**Boggabri Coal Mine - Project Approval Modification  
Environmental Assessment (MOD 5)**

**Response to Submissions Report**

2 May 2016

Client: Idemitsu Australia Resources  
Title: Boggabri Coal Mine - Project Approval Modification Environmental Assessment (MOD 5)  
Subtitle: Response to Submissions Report  
Document No: 2200545A-ENV-REP-005 RevI  
Date: 2 May 2016

**Figure 3.2**  
Groundwater modelling drawdown contours - Rodstrom property

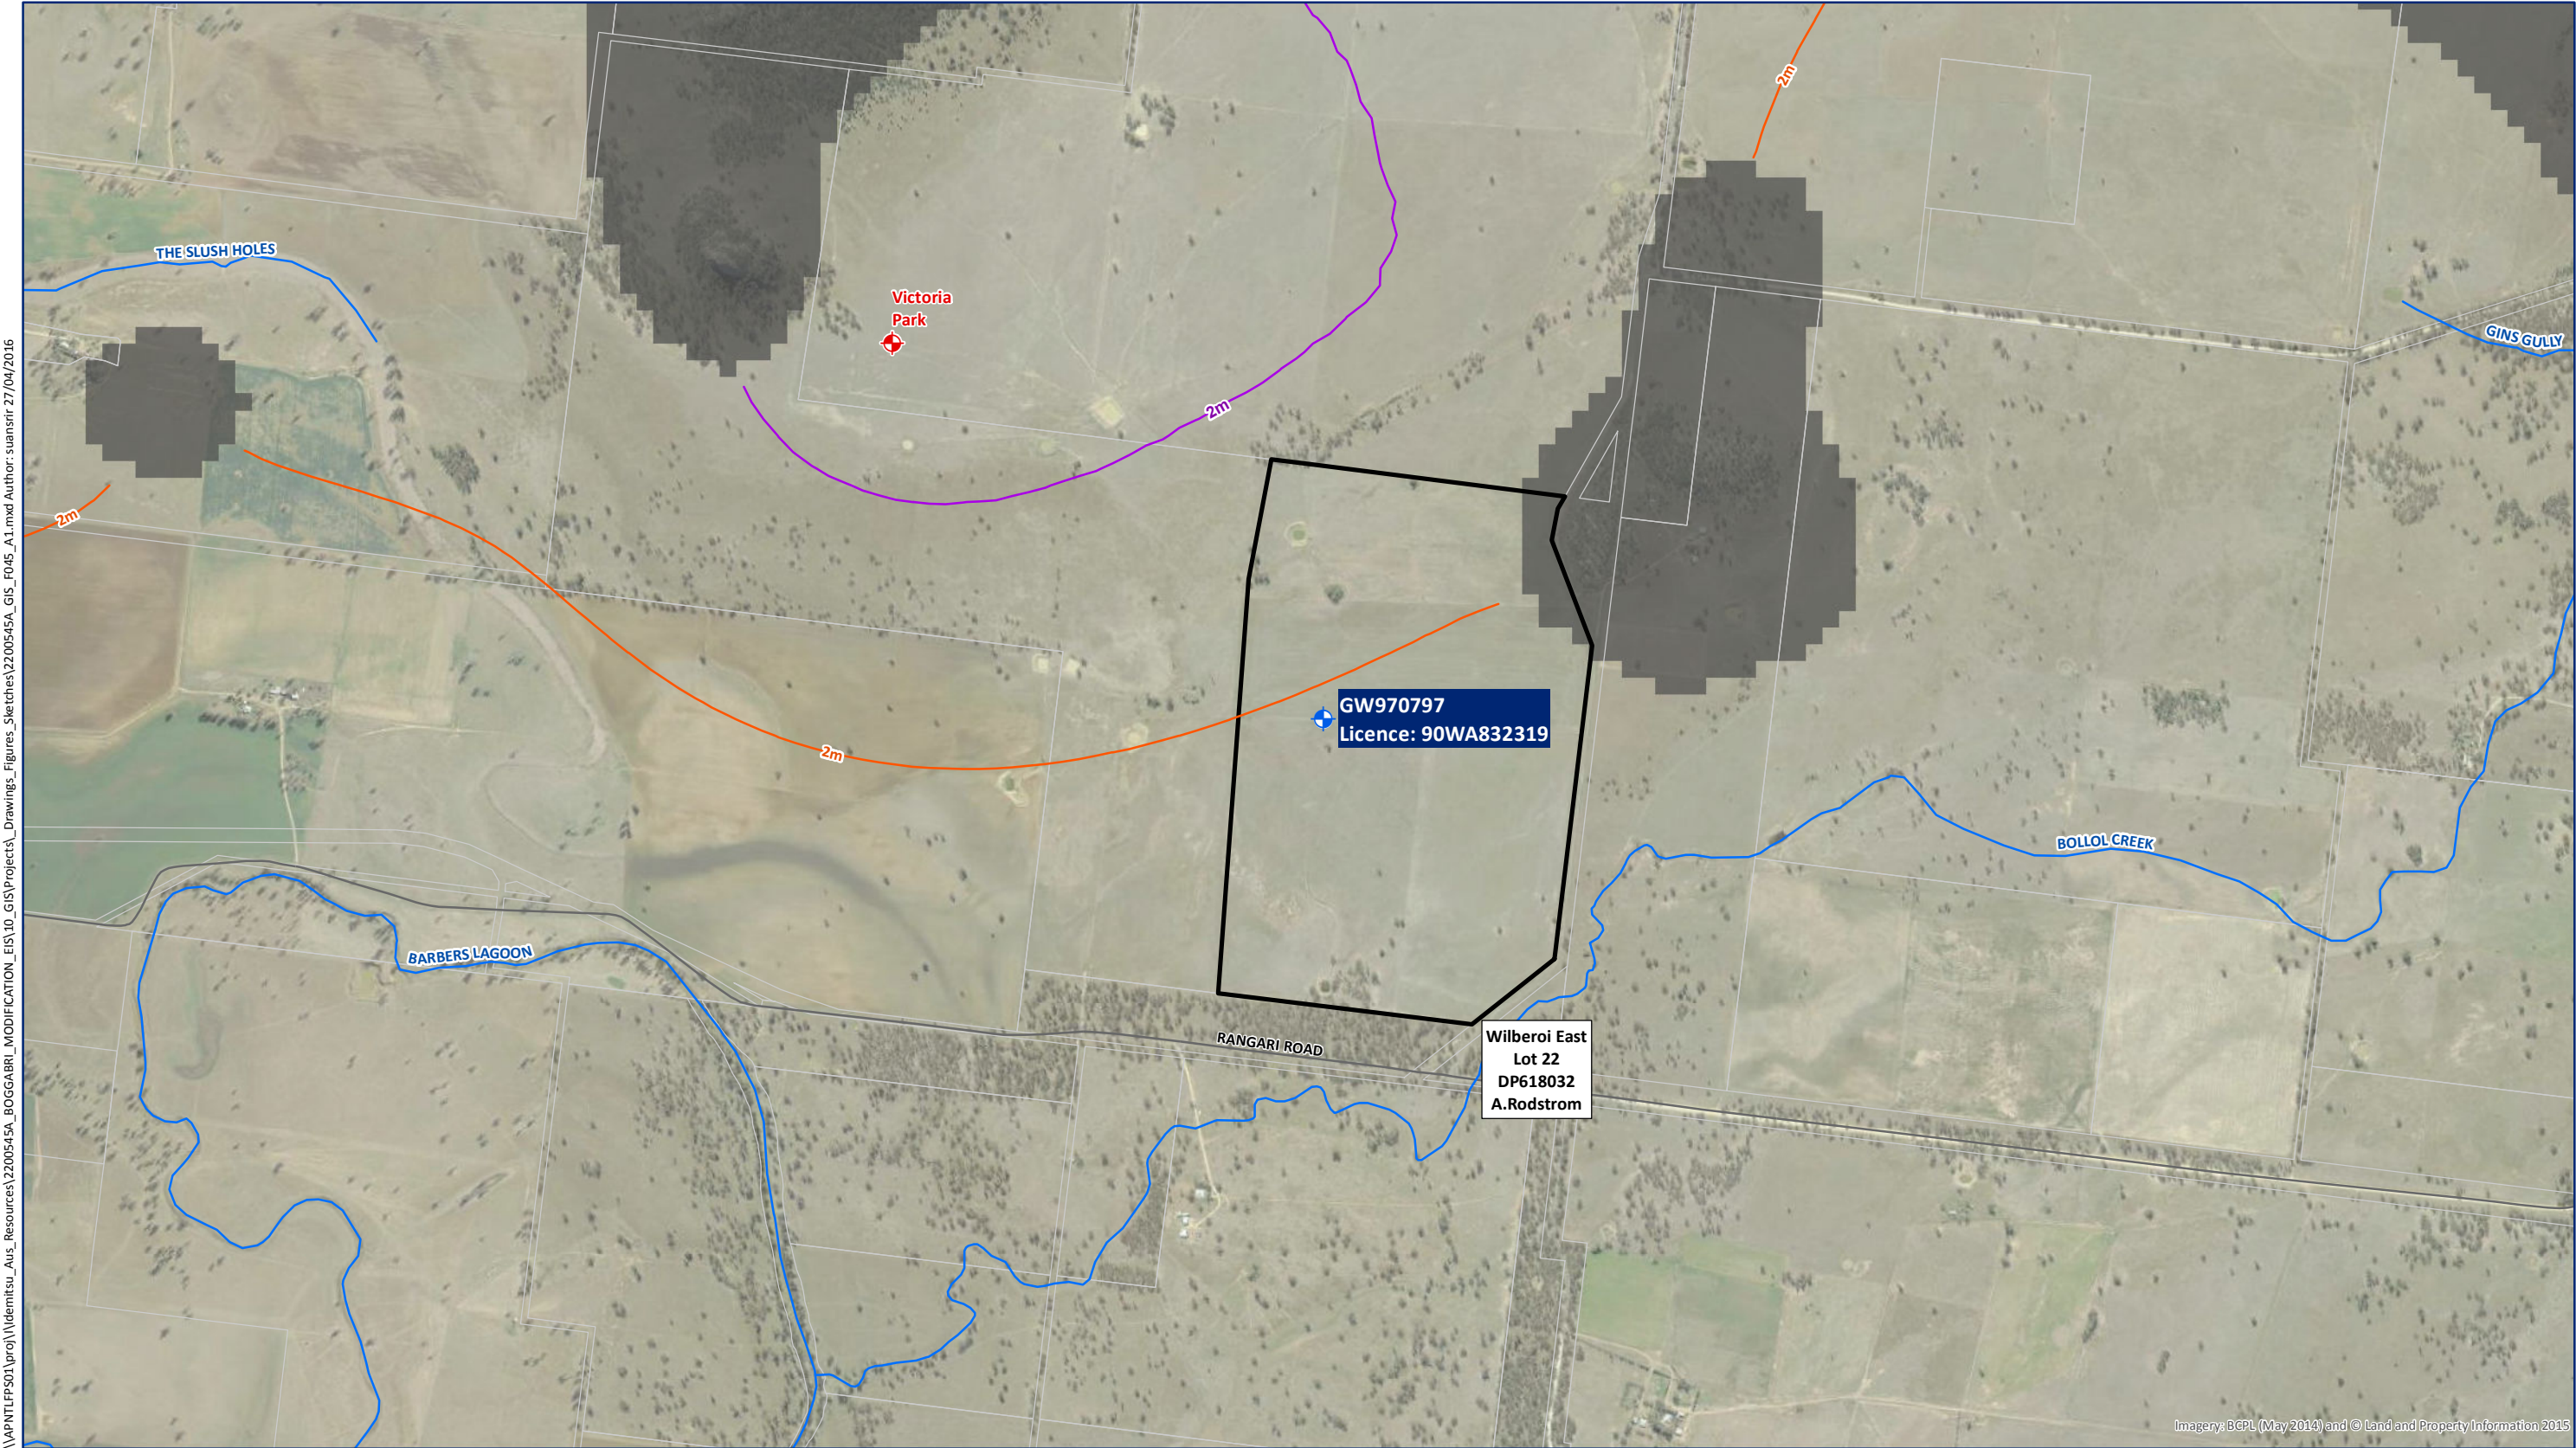
A groundwater study based on a complex modelling platform that has been calibrated against more than two years of suitable baseline data has been undertaken. This was consistent with Australian Modelling Guidelines. The model predicts that 2m drawdown during extended dry conditions, when increased pumping rates from the proposed borefield are likely, will not occur at the stock and domestic bore on Mr Rodstrom's property.

Boggabri Coal undertook a modelling exercise to determine the potential drawdown impact to Mr Rodstrom's stock and domestic bore from various Victoria Park bore extraction regimes. The model determined that during extended dry periods, when an increased extraction rate is likely, 2m draw down will extend to 99m from Mr Rodstrom's bore. The model also determined that during average weather conditions, when lower extraction rates can be expected, 2m drawdown will extend to 996m from Mr Rodstrom's bore. Figure 3.2 illustrates the modelled drawdown extents.

In 2015 and early 2016 Boggabri Coal undertook monitoring of the stock and domestic bore on Mr Rodstrom's property in order to inform future monitoring that may be required to assess the drawdown impact from operation of the proposed borefield.

**Figure 3.3**  
Groundwater modelling drawdown contours - Picton property

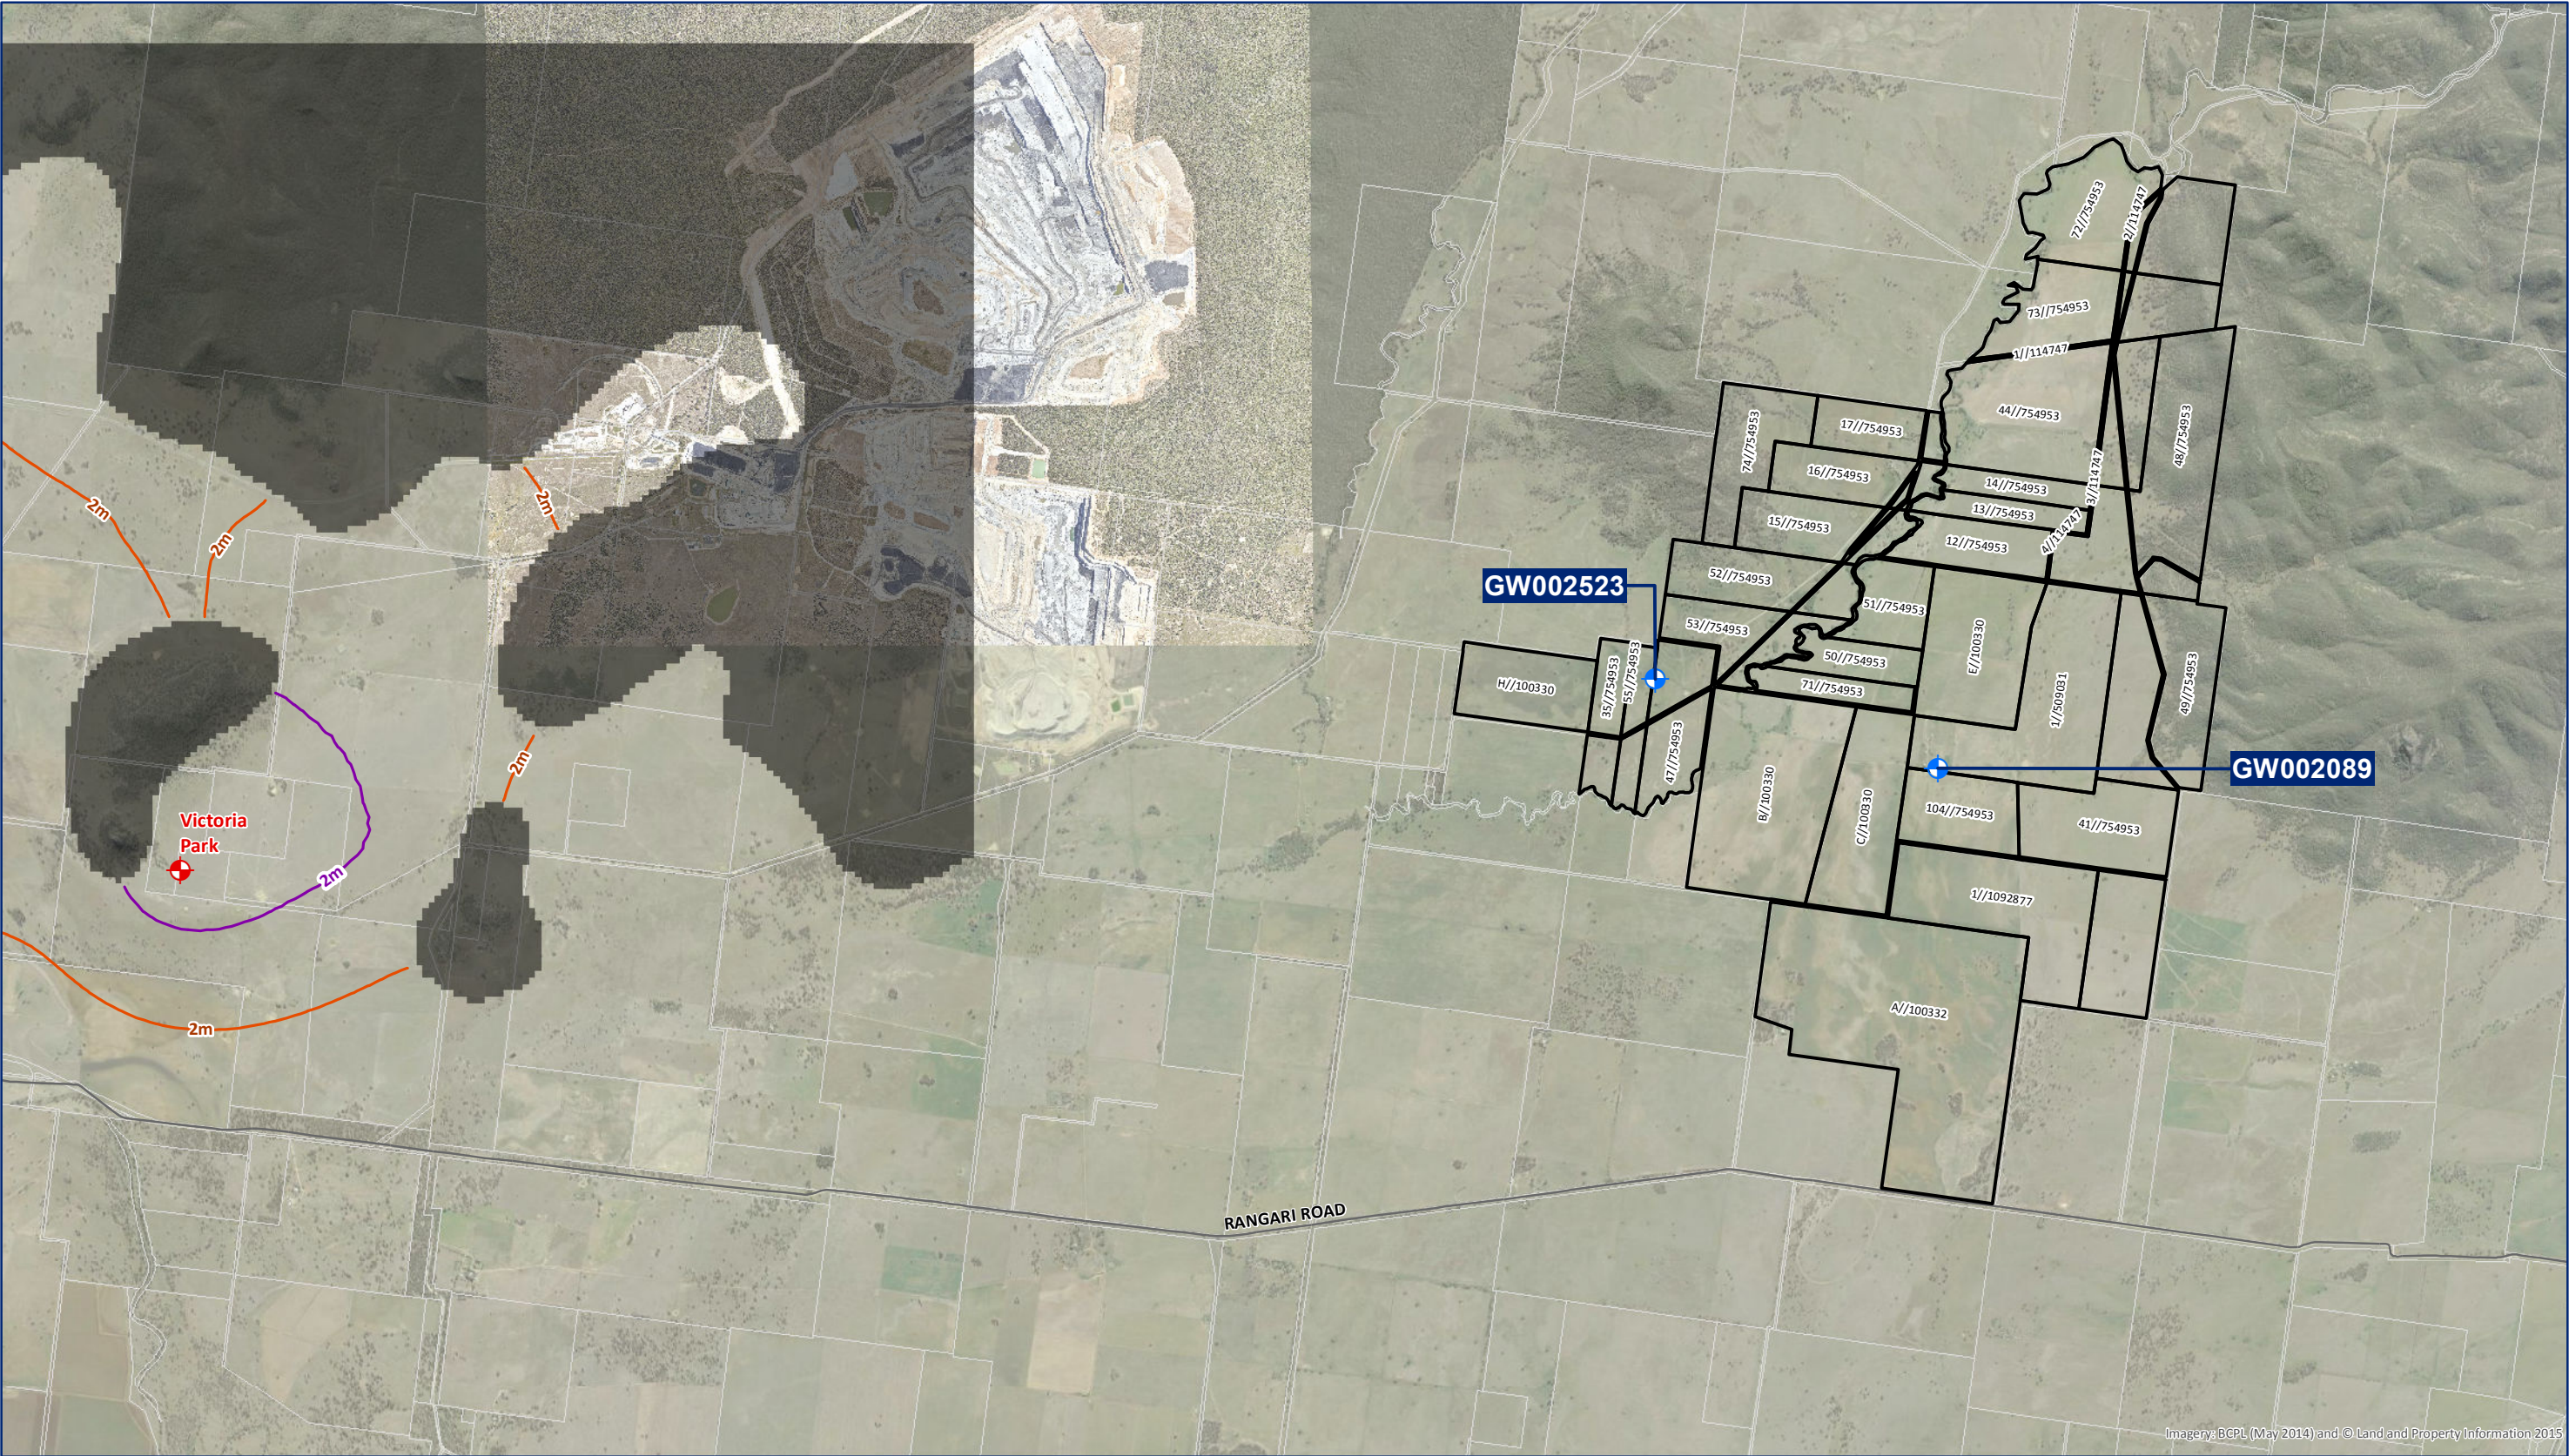
Issue	Response
Concerned about the affects the proposed borefield will have on their farming/business operation and domestic use as they are neighbouring the proposed site to the east. Highlight the lack of communication between farmer and mining company.	<p>Impacts of groundwater drawdown on surrounding water users was assessed as part of the groundwater assessment undertaken for the modification (refer Section 6.1 and Appendix B Drawdown Impact Assessment of Proposed Borefield Operation of the MOD 5 EA).</p> <p>Minimal drawdown impacts on active landholder bores during average weather conditions are expected. However, during extended dry conditions when increased pumping rates from the proposed borefield are likely, drawdown greater than 2m is predicted in some private bores and wells.</p> <p>Boggabri Coal will operate an expanded groundwater monitoring program (following consultation with DPI Water) to monitor the effects of the proposed borefield. The expanded groundwater monitoring program will measure groundwater drawdown levels in the proposed borefield area and identify when Boggabri Coal is required to cease or alter its extraction regime in order to avoid causing drawdown greater than 2m at any privately owned groundwater supply works.</p> <p>Data from a ground water monitoring bore located in the Picton property and bores on neighbouring properties will be used to determine the impact of the operation of the proposed bore field on Mr Picton's ground water supply. The bores inside Mr Picton's property will be included in the next round of hydrocensus monitoring.</p> <p>Where it is identified that Boggabri Coal groundwater pumping has caused a groundwater drawdown greater than 2m, resulting in a reduction of water availability to the owner of an affected groundwater supply, then Boggabri Coal will enter into negotiations with the affected stakeholder to identify suitable "make good provisions".</p> <p>Agreements will be subject to 'make good' provisions negotiated between Boggabri Coal and the owner of the affected groundwater supply works.</p> <p>Groundwater users who are impacted by the modification are subject to 'make good' provisions that may include provision of access to an equivalent supply of water through enhanced infrastructure or other means, such as deepening existing bores, funding extra pumping costs or constructing new pipelines or bores and/or other compensatory measures.</p> <p>Groundwater users predicted to be subject to drawdown impacts use their bores for stock and domestic purposes with a single bore being used for irrigation. As these users will be subject to 'make good' provisions if drawdown impacts occur, no negative effects are expected to be realised.</p> <p>Boggabri Coal has undertaken extensive consultation with the owners of groundwater supply works predicted to be impacted by the operation of the proposed borefield.</p> <p>The extent of consultation for the proposed modification is outlined in Section 5.1 of the MOD 5 EA.</p> <p>As noted in Section 5.2 of the MOD 5 EA, Boggabri Coal has committed to further consultation with landholders whose bores or wells may be impacted by the modification. Mr Picton will be included in the borefield consultation process.</p>

Issue	Response
<p>Proposes the question; what water studies have been completed to protect our supply and our livelihood?</p>	<p>A Drawdown Impact Assessment based on a complex modelling platform that has been calibrated against more than 2 years of suitable baseline data and is consistent with Australian Modelling Guidelines has been undertaken. The model predicts that 2m drawdown during extended dry conditions, when increased pumping rates from the proposed borefield are likely, will not occur at any registered bores on Mr Picton's property. Figure 3.3 illustrates the modelled drawdown extents.</p> <p>The confidence level of the model in reference to National Water Commission guidelines (2012) is Class 2–3. The modelling platform has been independently reviewed by HydroSimulations and deemed fit for purpose and reliable.</p> <p>The Drawdown Impact Assessment has been completed in accordance with and assessed against the Aquifer Interference Policy to ensure minimal impact to the supply of water and those upon which their livelihood relies.</p> <p>The Drawdown Impact Assessment has review by DP&amp;E and DPI Water. DPI Water's review has found no errors or deficiencies in the modelling, including the climate scenarios and cumulative drawdown assessments, that would limit the validity of the results.</p> <p>A copy of the Drawdown Impact Assessment is provided in Appendix B and summarised in section 6.1 of the MOD 5 EA.</p>
